FINAL VICTORIA GARDENS BOULEVARD SIDEWALK FEASIBILITY STUDY

CITY OF PORT ORANGE, FLORIDA

AUGUST 2015

Response to FDOT Comments

VICTORIA GARDENS BOULEVARD TYPICAL SECTION
OPTION 2 - 5' OR 8' SIDEWALK WITH GRAVITY WALL

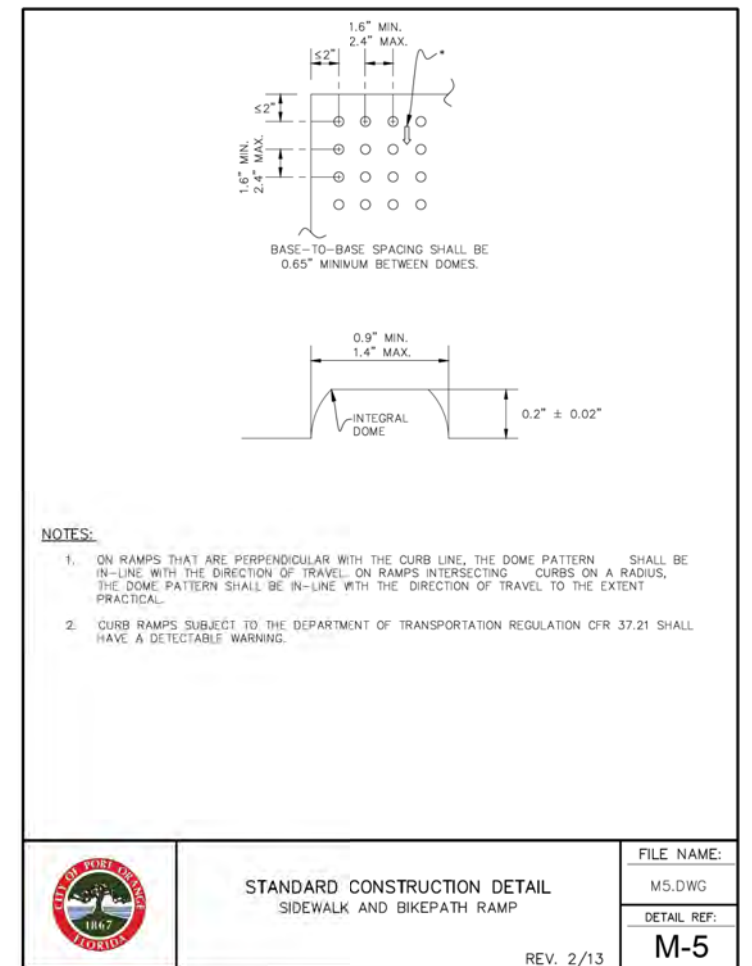
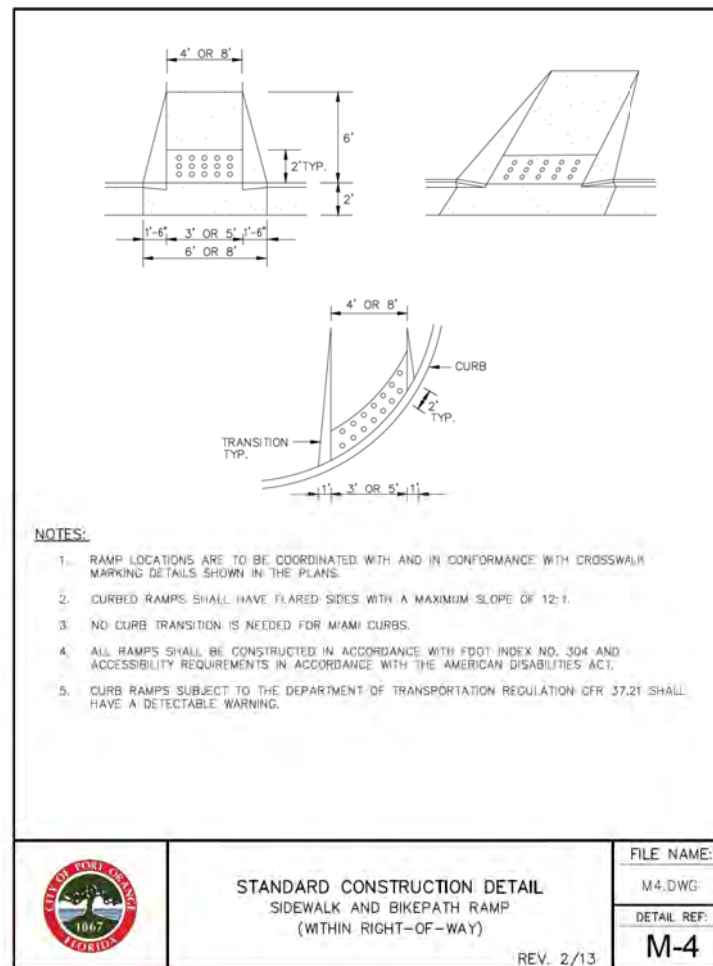
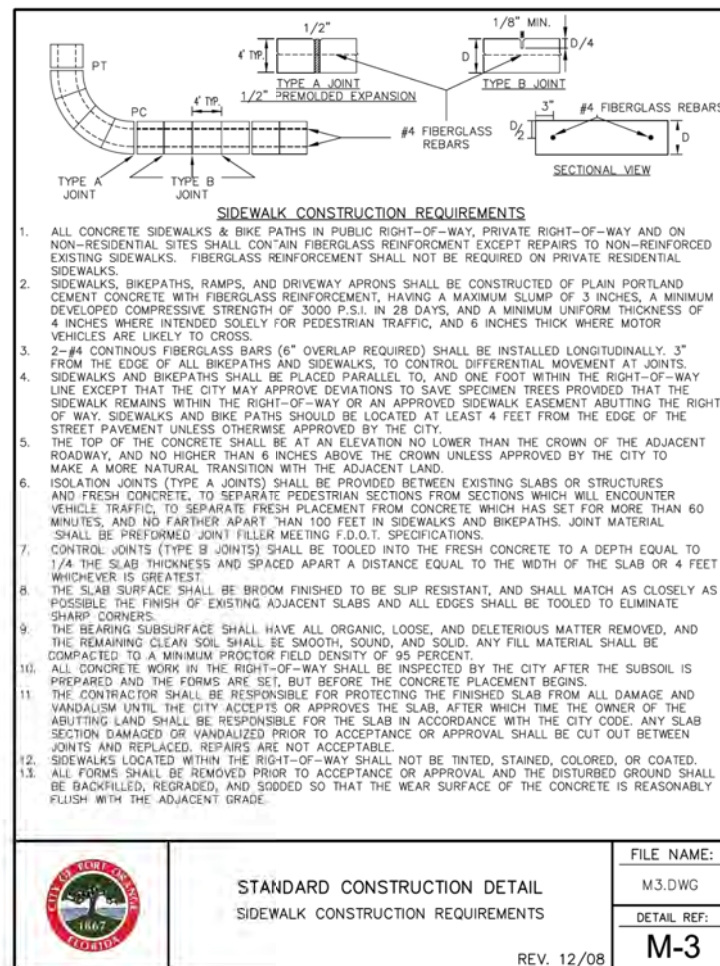
Comment #1: In the feasibility study, it is suggested that the project has sufficient R/W to construct the proposed facilities. But when examining the concept plans, we noticed that slope stabilization outside of the R/W may be required to tie in to existing ground.

Response: The conceptual recommendations along the corridor have been revised to include a wall to be constructed within the right-of-way to remove the need for work outside of the right-of-way. The planning level cost estimate has been updated accordingly.
